Notice of Allowability

10/733,138

GODEFROID, ALAIN JOSEE
JOSEPH

Examiner's Amendment

FIG-1

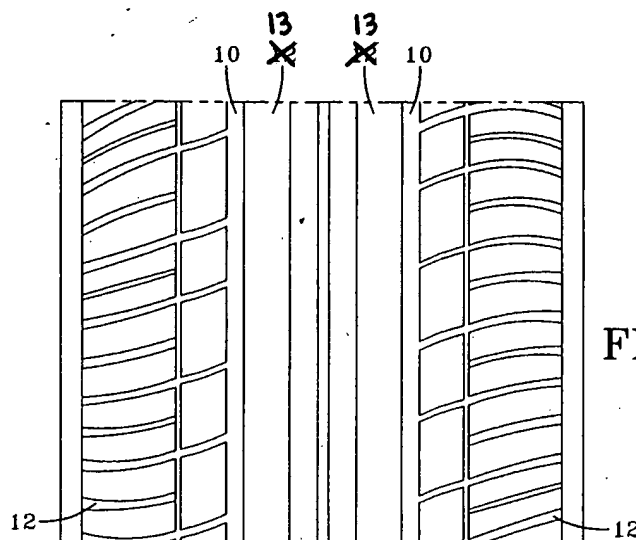
Amend figure 1 as follows: At the top of figure 1, change both occurrences of "12" to --13--. These changes are indicated below:
